SHEARON HARRIS NUCLEAR POWER PLANT  
FAULT INVESTIGATION

Responses to Mr. W. R. Butler's  
letter of 16 May, 1975

**FIGURE 1 SCHEMATIC EPISODE - TEMPERATURE HISTORY CHART**

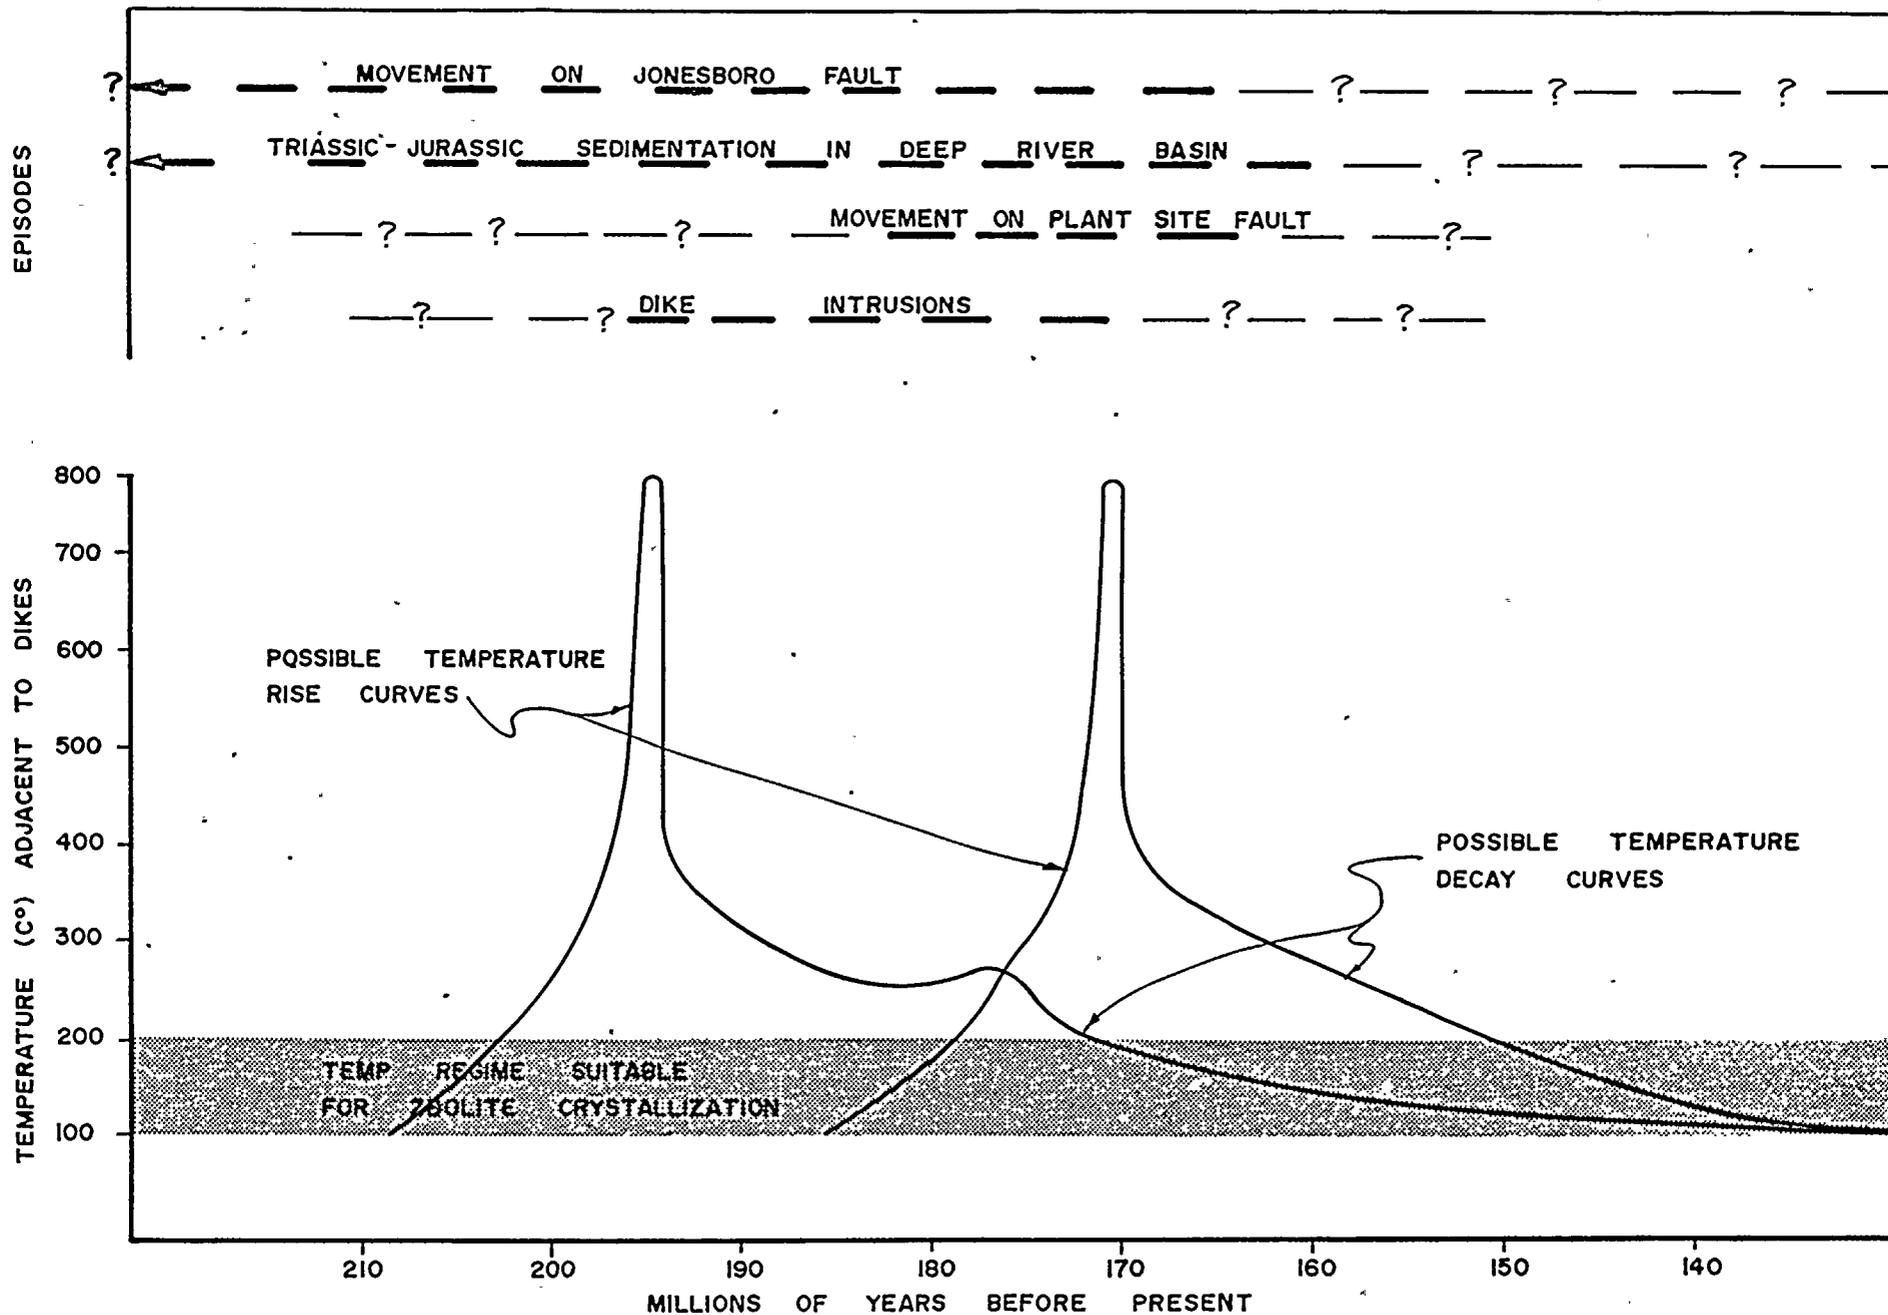
Discuss evidence for an episode of regional metamorphism other than paleomagnetism and a general discussion of burial metamorphism, as well as the need for such an episode in determining the capability of the site fault. This discussion should include considerations of the temperature - pressure - phase relationships of the zeolite minerals examined.

In the context of the present Fault Investigation Report, it is intended to be understood that "burial" metamorphism requires only that depth of cover which is necessary to form sufficient thermal insulation to sustain temperatures of 100° C plus for geological periods of time on an areal basis. The recent suggestion by Dallmeyer (1975) that some rock units earlier considered to be Triassic may in fact be Jurassic is consistent with the interpretation that the low - grade metamorphic event described in the Fault Investigation Report is of Jurassic age. A schematic chart of possible episode - temperature correlations is enclosed as Figure 1.

**Figure 2**  
**SECTION THROUGH POSITIONS**  
**1-2-3-4**

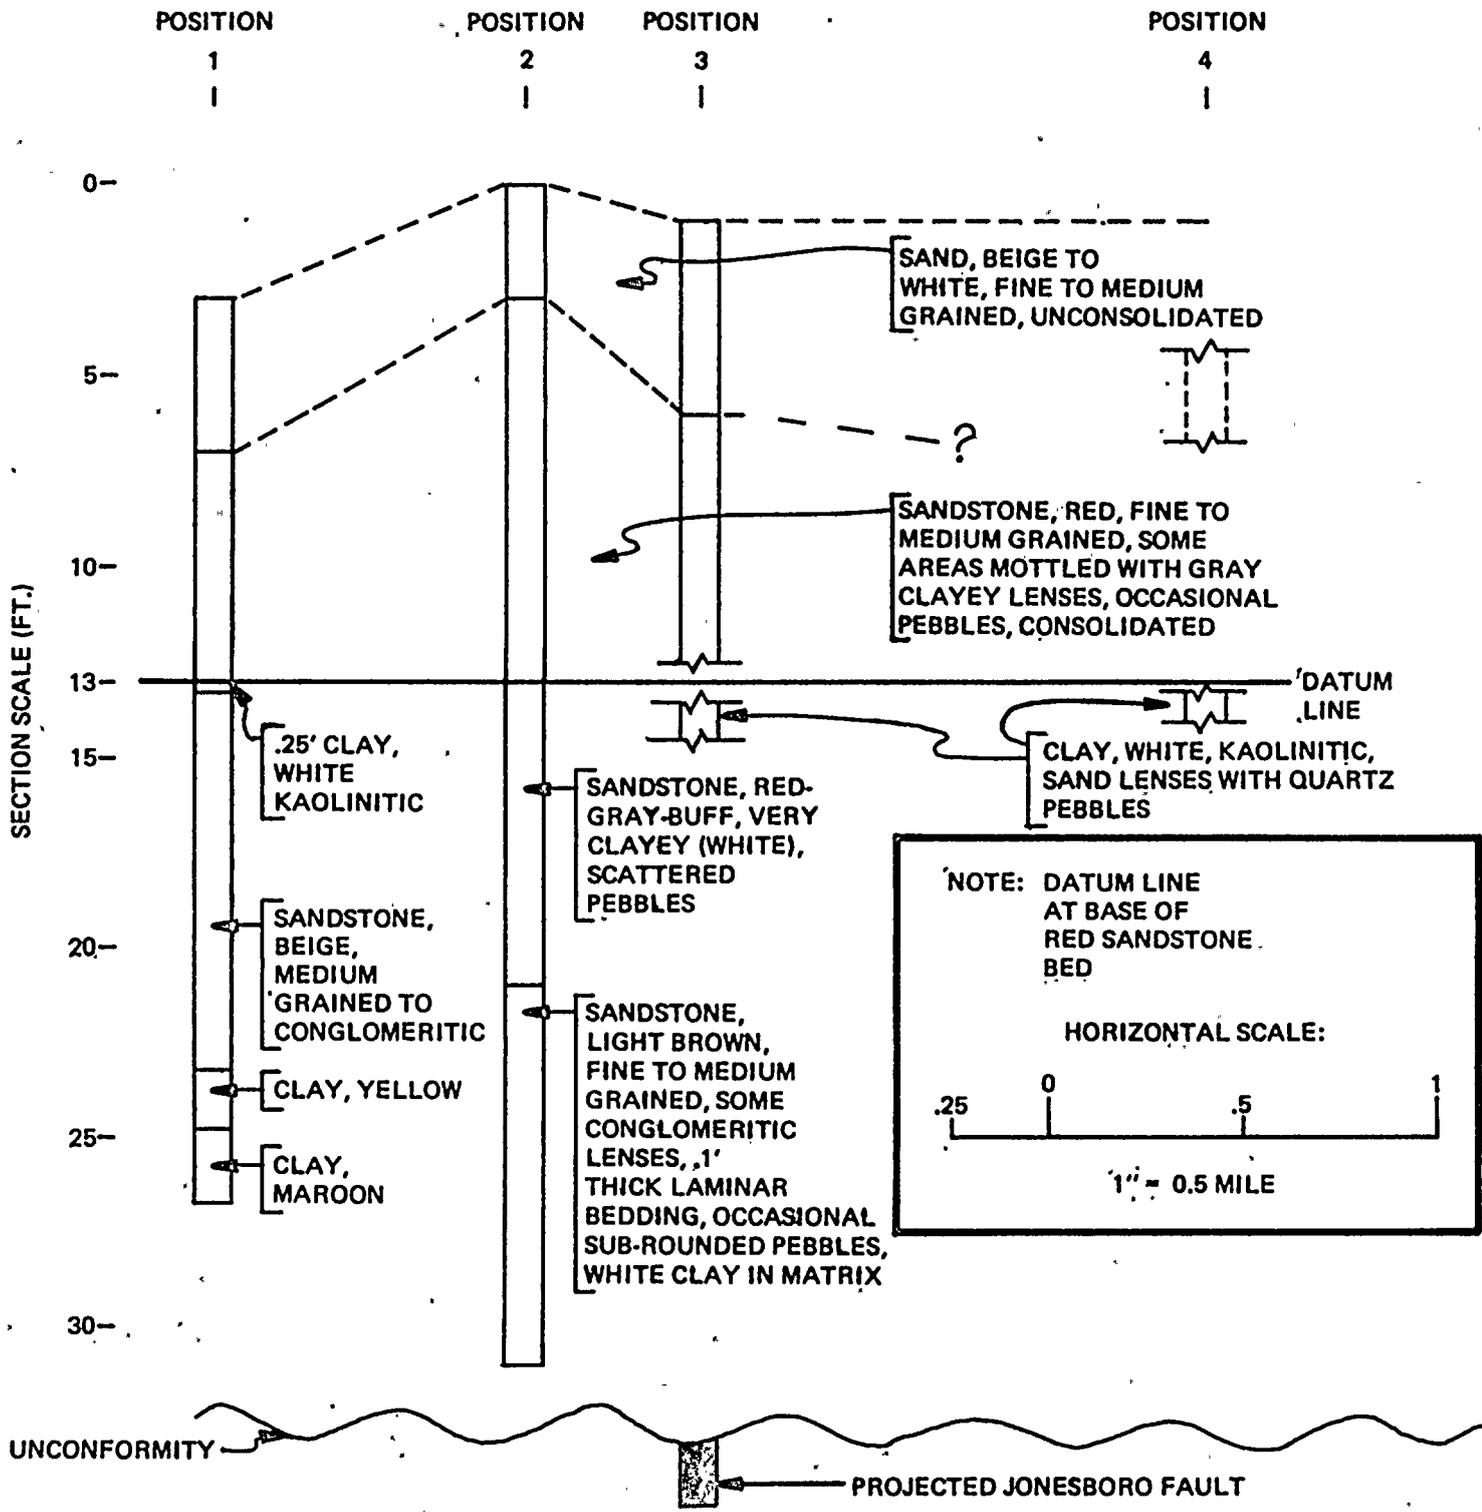
Provide further documentation of the lack of offset of Cretaceous (?) rock by the Jonesboro Fault. Include items such as maps, photos, etc.

- 1) Horizontal bedding was observed in the Cretaceous beds where they are well exposed, and good correlations of these beds can be carried across the projected location of the fault with no apparent offset.
- 2) No jointing or any other evidence of deformational strain is present in the observed exposures of the Cretaceous deposits. Particularly significant is the lack of strain in the exposure overlying the projected location of the fault (Position 3).
- 3) No apparent fault controlled drainage is exhibited in the development of the dendritic stream pattern throughout the area underlain by Cretaceous deposits.
- 4) The residual sandy soil, derived from the Cretaceous deposits, is the same and supports the same vegetation on either side of the projected location of the fault.

**FIGURE 3**

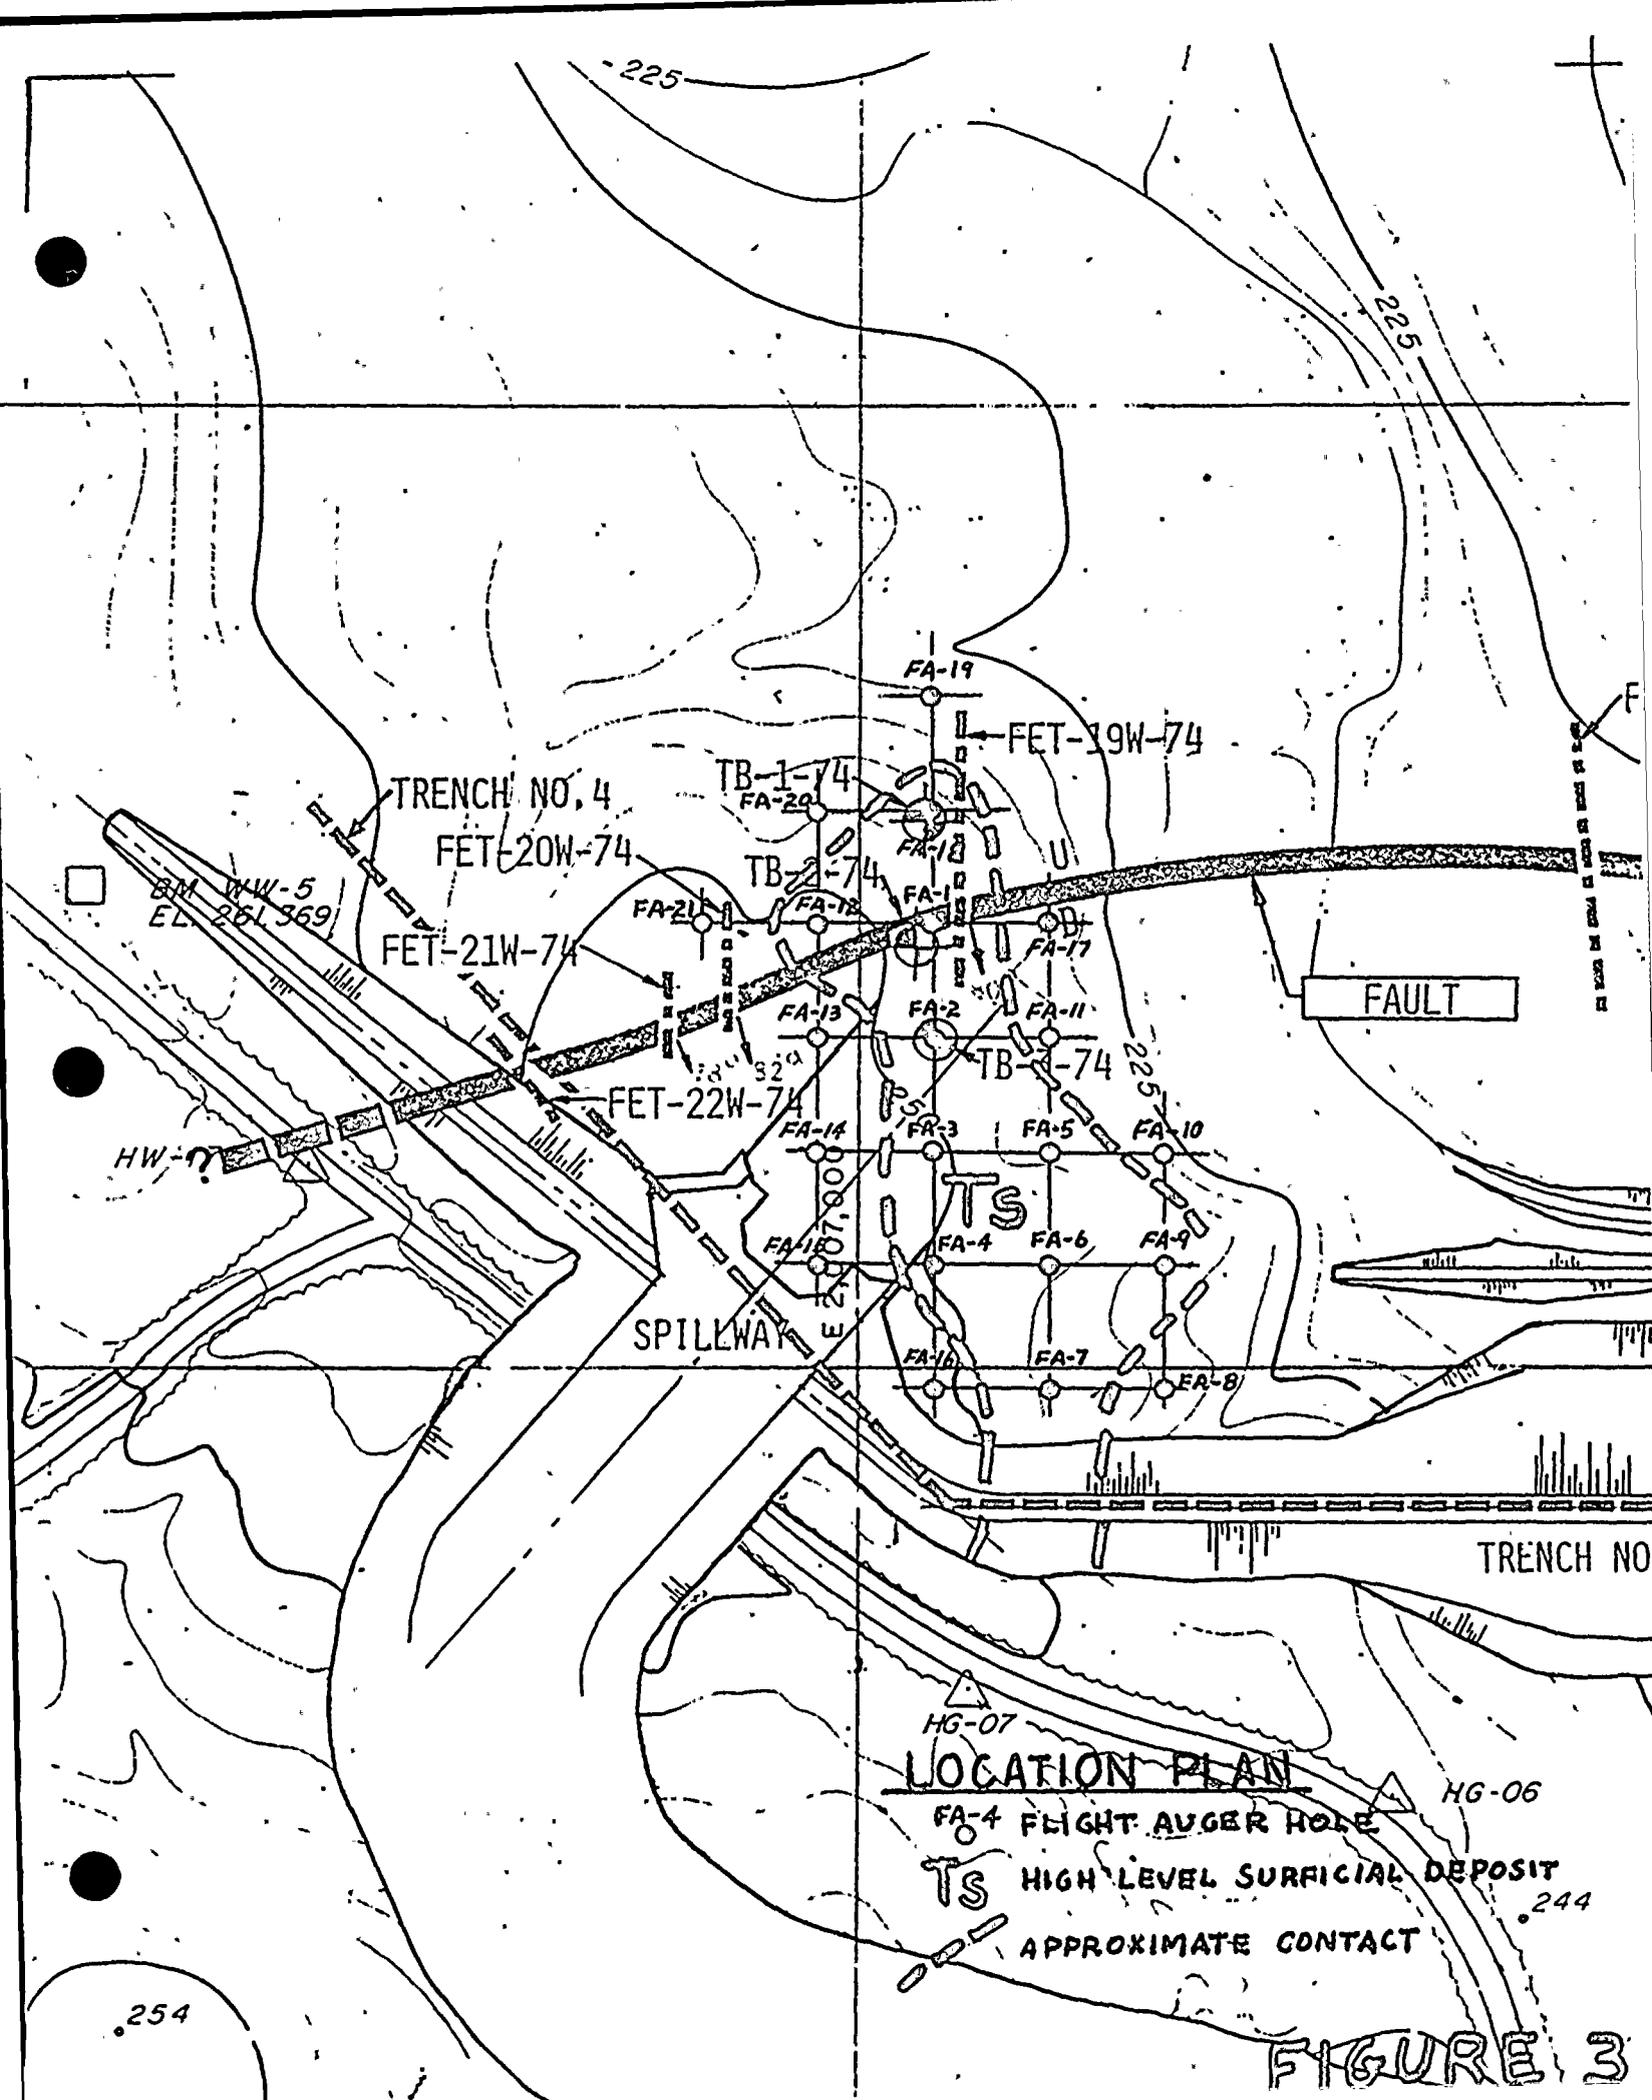
Provide all evidence available to support your statement that the site fault is overlain by undisturbed Pliocene strata.

Of the 21 borings, seven encountered an apparent basal layer containing rounded quartz pebbles immediately overlying bedrock and three encountered traces of clean uniform sand. This information, combined with the relatively deeper soil depths at these locations was judged to indicate continuations of the same High Level Surficial Deposit exposed in Trench FET-19W and limits were drawn accordingly (see accompanying location plan, Figure 3.)
